## BGA TECHNICAL COMMITTEE

### TECHNICAL NEWSHEET 7/8/98

#### PART 1     Airworthiness "AGGRO"

ROLLADEN-SCHNEIDER Flugzeugbau GmbH LBA-Nr. EB - 4	Technical Bulletin No. 56 <i>LS. 1</i>	all LSI " <i>LS 3</i> "	Page 1/1 Edition Mar. 98
--	---	----------------------------	-----------------------------

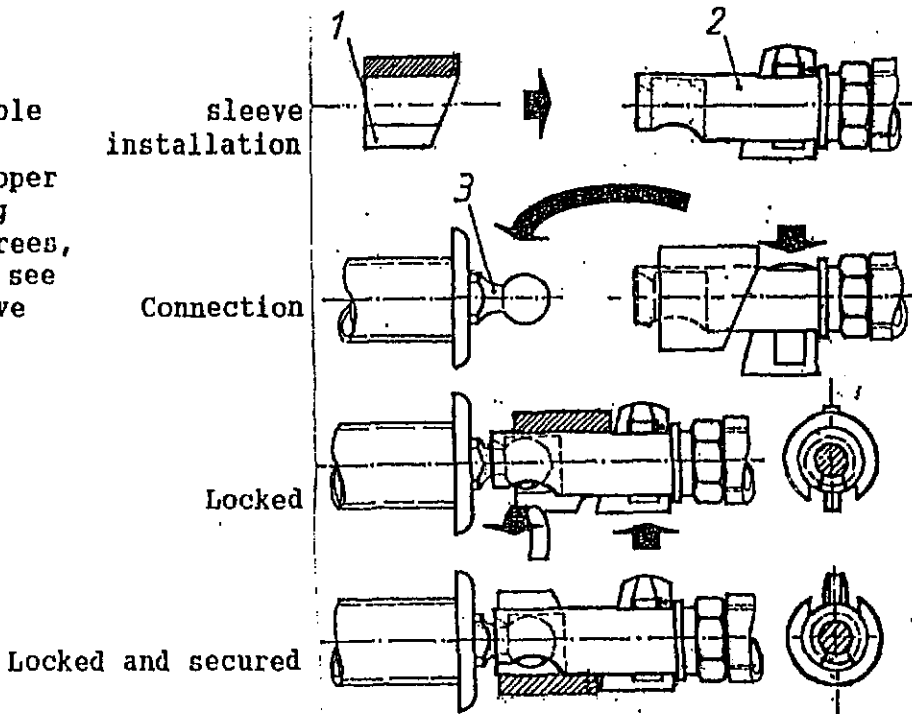
Subject : Securing of Hotellier control system connectors (a.k.a. ball snap joints or clip and ball coupling) according to LBA-AD 93-001

Reason : These connectors may open during use when they are not correctly assembled.

Material and Instructions : Securing may be performed using sleeve "white" 4R10-188 according to specification SR10-188 dated 04.03.98. This sleeve replaces the securing pin according to LBA-AD 93-001. Slide the sleeve only axially onto the disassembled connector with the slot over the ball opening, from now on it should always stay on the connector. After assembly of ball and connector, rotate sleeve by 180 degrees to secure system.

Sleeve installation according to drawing 4BF-164. Insert page "Flight Manual LBA-AD 93-001/3" into Flight Manual, 3 pages "TB-AD-Accomplishment List for Periodical Inspections" into Maintenance Manual (Instructions for Continued Airworthiness) and update list of valid pages. Corresponding pages of both manuals with Edition May 93 must be removed.

# T.49 CAPSTAN - Rudder Cables.

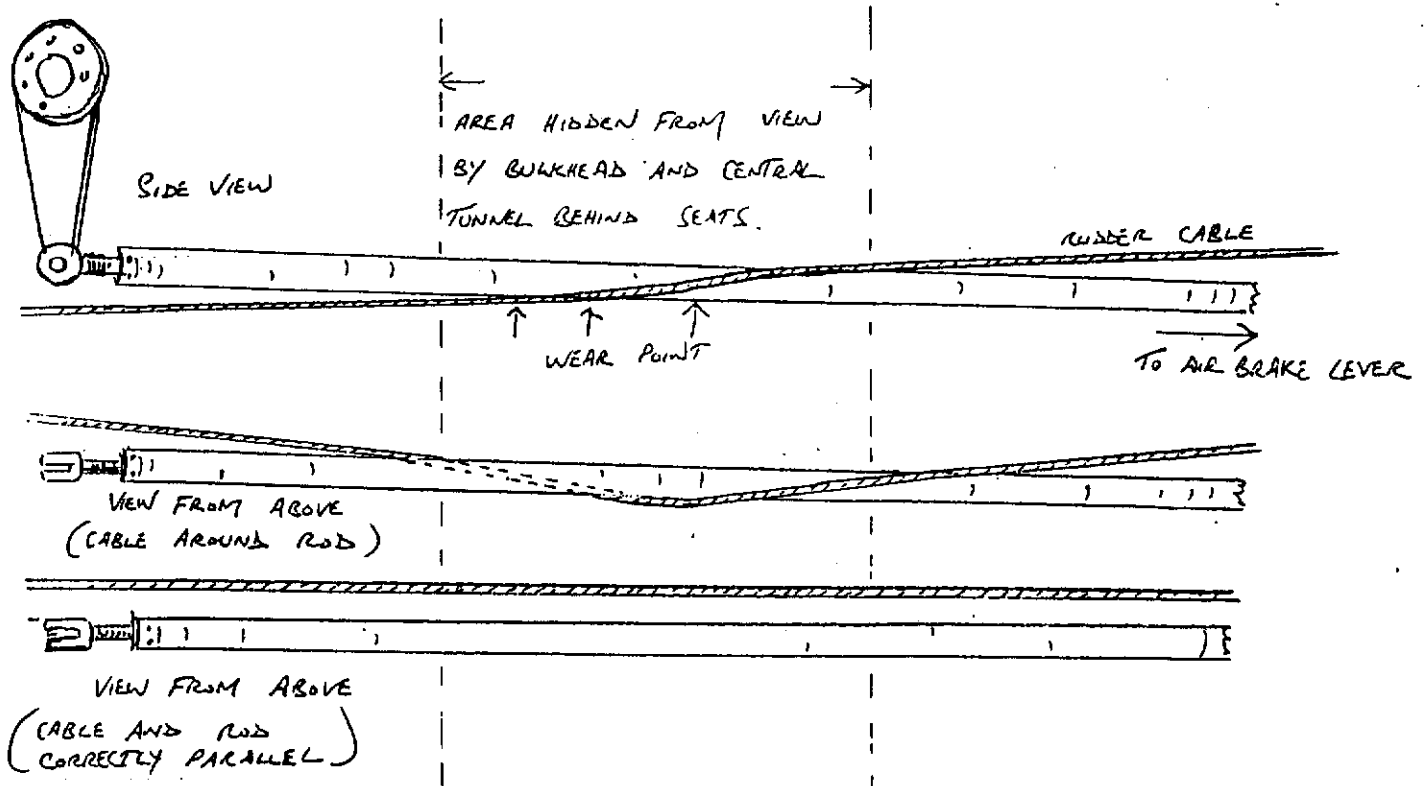
- 1.10.    CAPSTAN RUDDER CABLES Sketch from Ulster G.C. illustrates a possible problem.
- 1.11.    MT PROPELLERS. LBA Directives - the current list is attached.

T49 CAPSTAN - STARBOARD RUDDER CABLE FOLLOWING  
AIRBRAKE CONNECTING ROD:

WITH RUDDER CABLES DISCONNECTED AND LYING SLACK, IT IS POSSIBLE TO ASSEMBLE AIRBRAKE CONNECTING ROD WITH STARBOARD RUDDER CABLE LOOSELY DRAPED OVER ROD AND HIDDEN FROM VIEW AS PER SKETCH.
